Peer Review of Demonstrating the Safety and Crashworthiness of a 2020 Model-Year, Mass-Reduced Crossover Vehicle (Lotus Phase 2 Report)

EPA-420-R-12-028
September 2012

SUBJECT: Peer Review of *Demonstrating the Safety and Crashworthiness of a 2020 Model-Year, Mass-Reduced Crossover Vehicle (Lotus Phase 2 Report)*, developed by Lotus Engineering, Inc.

Figure 17. Vehicle subframe deformation for NCAP test

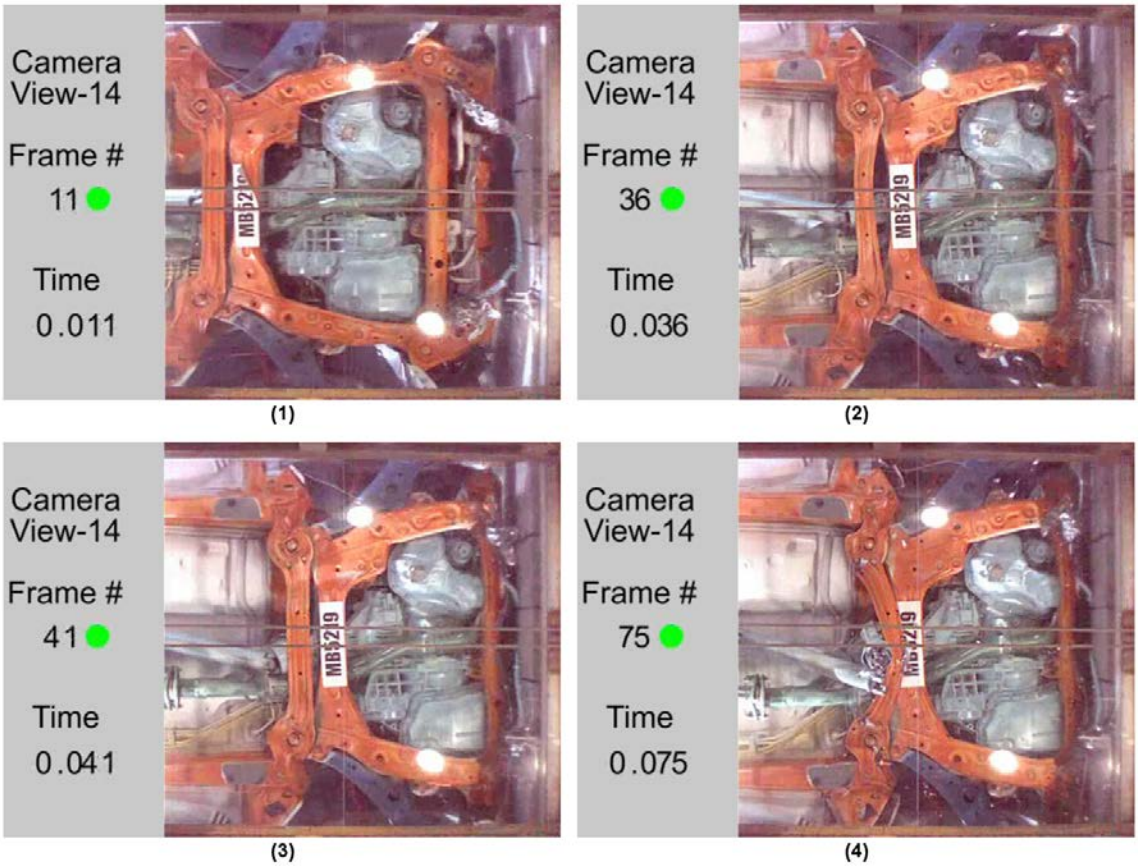
The following images are from the NHTSA NCAP crash test 7179 for 2011 Toyota Venza. The response is essentially the same as for the 2009 version, but the images are of much higher quality so that they have been selected for comparison. These times corresponding to the times in Figures 15 and 16 are shown in Figure 17

The subframe starts to rapidly break off of the vehicle floor around 40 ms, and therefore allows for additional deformation. In Lotus vehicle this connection remains intact so that it cannot contribute to additional crash length. The left side view of the test vehicle during crash at the same times is shown in Figure 18.
